DIANA TELLEZ TRS
 OWNER
 220 31 STREET
 MIAMI BEACH, FL

VIOLATIONS TO BE FIXED

VIOLATION CASES:
 BVC19000449 AND BVC19000436 TO BE SOLVED

PLUMBING CAP DETAIL
 SCALE: N.T.S.

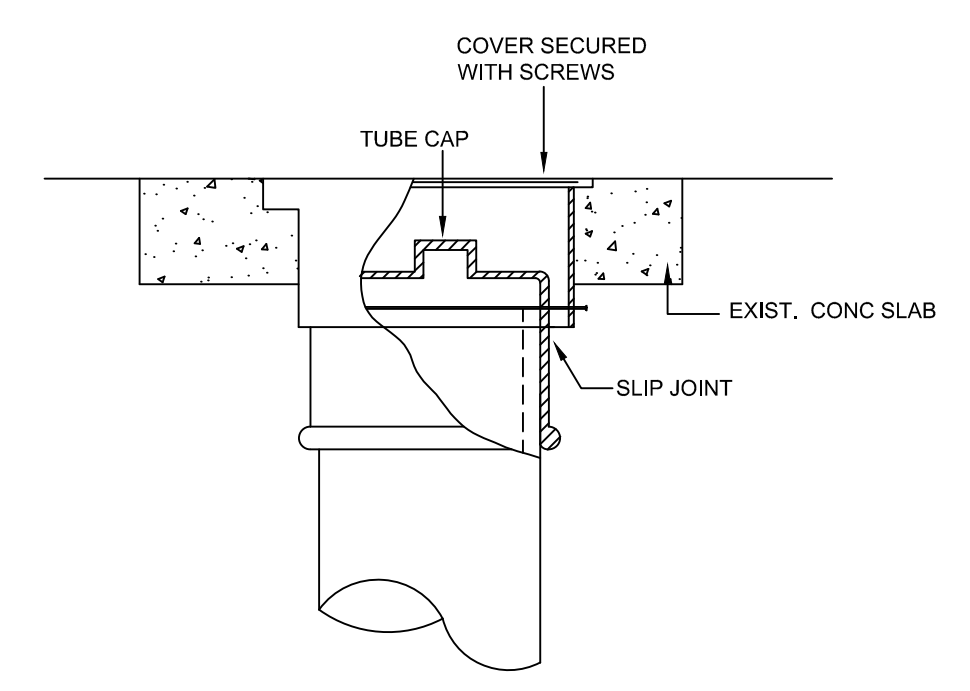
NOTICE OF VIOLATION. BVC19000436220 31 STREET.
 -Notice of Violation is in reference to the installation of a wooden roof structure at the rear of the property.
 WOODEN ROOF STRUCTURE TO BE DEMOLISHED

-Also, for the renovation of the bathroom in unit A14.
 BATHROOM IN UNIT 14 WAS SERVICED MAINTENANCE AS REQUIRED FOR CODE ENFORCEMENT.

NOTICE OF VIOLAITON BVC19000449. 220-224 31st St.
 -Boiler room with evidence of work done without approved permit and in violation of the Florida Building Code, safety conditions are compromised.
 BOILER ROOM TO BE DEMOLISHED

-Work done without approved permit, plumbing and electrical installations, wood fence and gate, laundry room without permit and inspections, also evidence spalling concrete and stucco work done. Flooding conditions at basement, temporary electrical installation needs to be removed
 LAUNDRY ROOM TO BE DEMOLISHED
 TEMPORARY ELECTRICAL INSTALLATION TO BE REMOVED
 BASEMENT HAS BEEN CLEANED AND DRY AND BACK TO ORIGINAL CONSTRUCTION

TYPICAL 2ND & 3RD FLOOR PLAN
 SCALE: 3/16"=1'

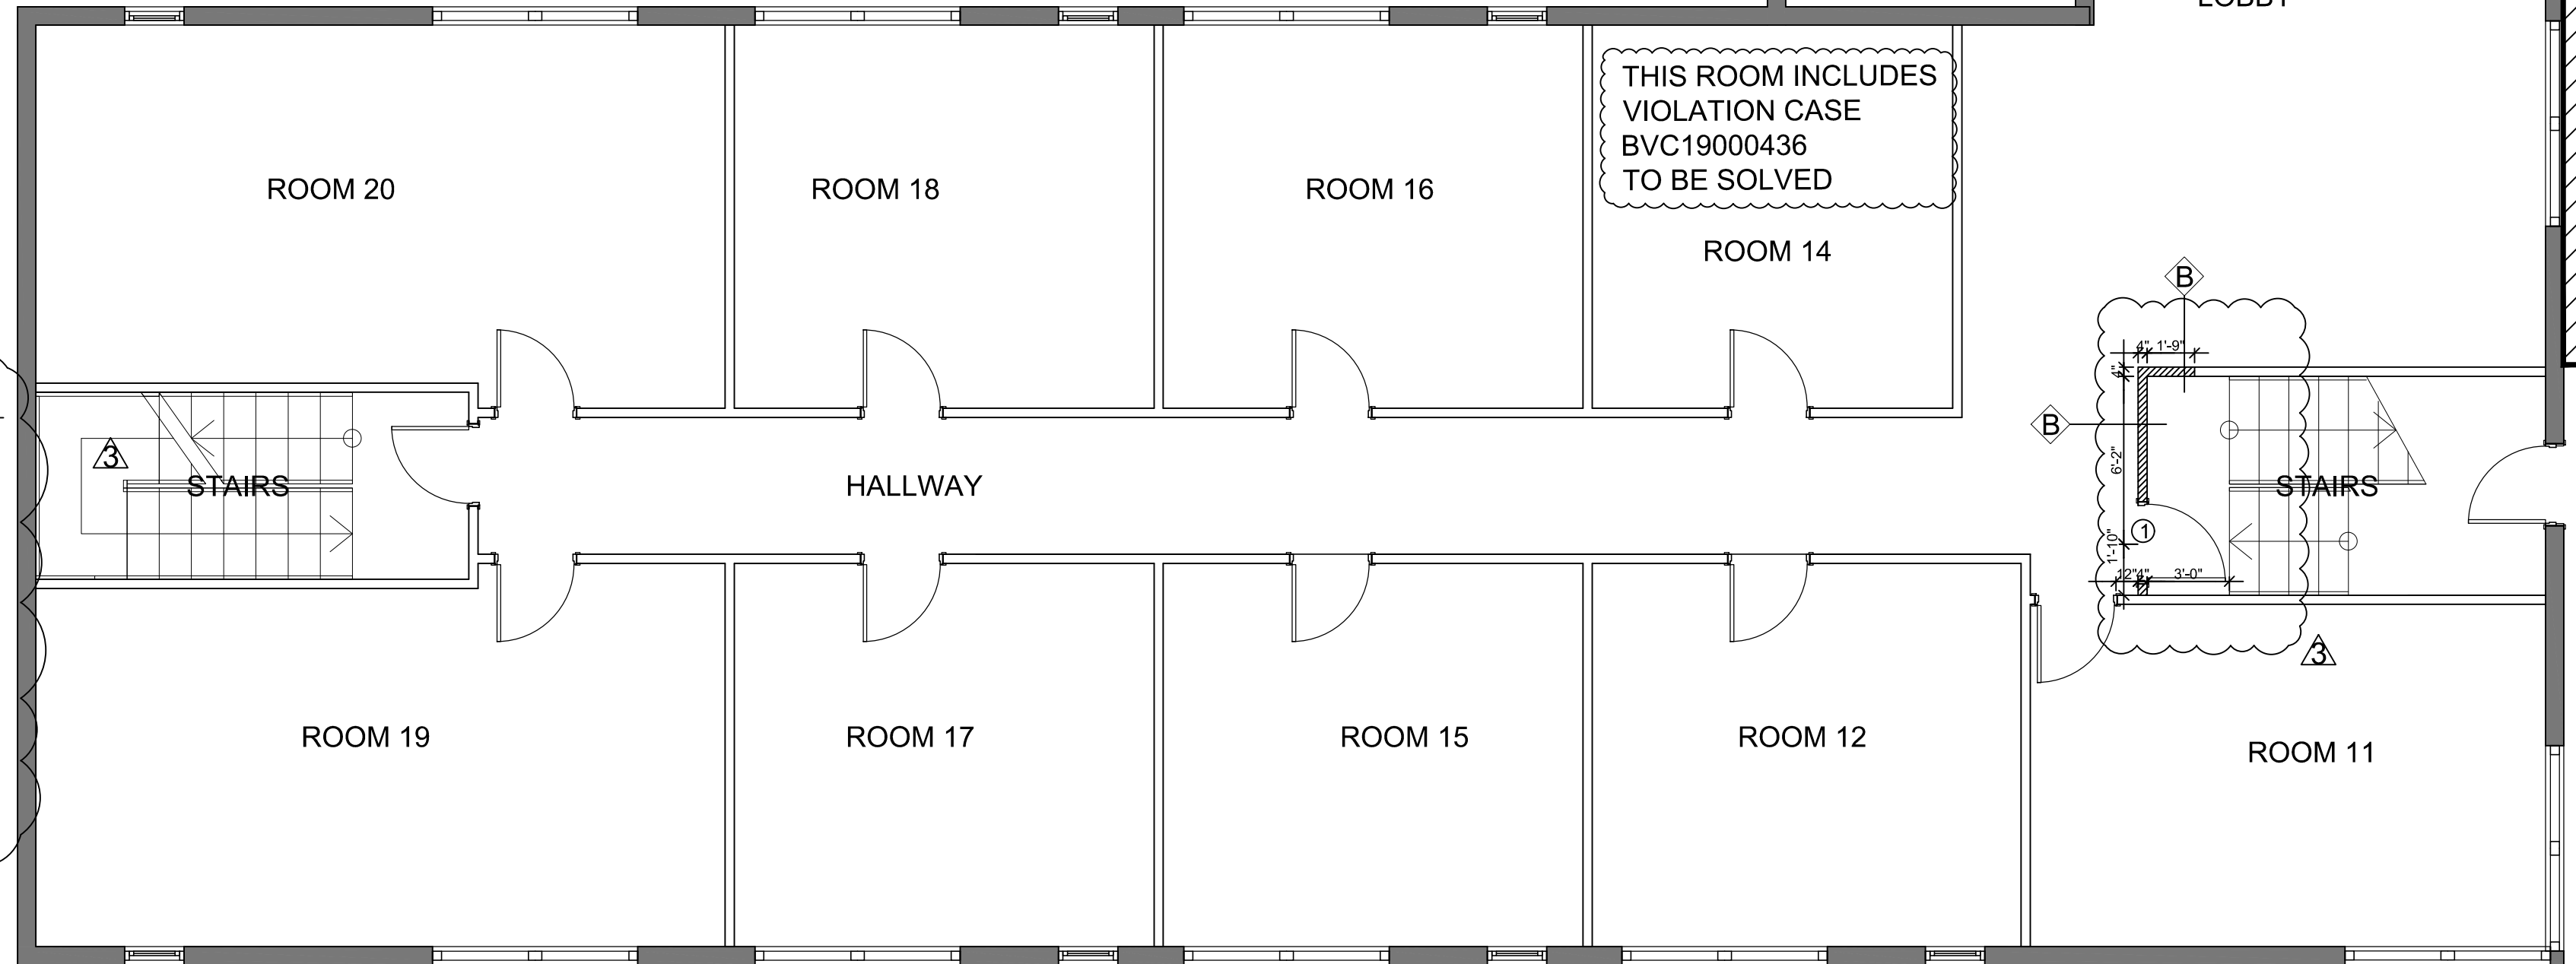
PLANNING REVIEW
 Revision horizontal railing to incorporate 6 inch opening above 36" A.F.F.
 R/. RAILING TO BE UP-DATED AS SHOWN ON SHEET S-1 RAILING 42" A.F.F WITH MAX 4" REJECT.

RAILING AREA TO BE UP-DATED
 SEE PLAN S-1
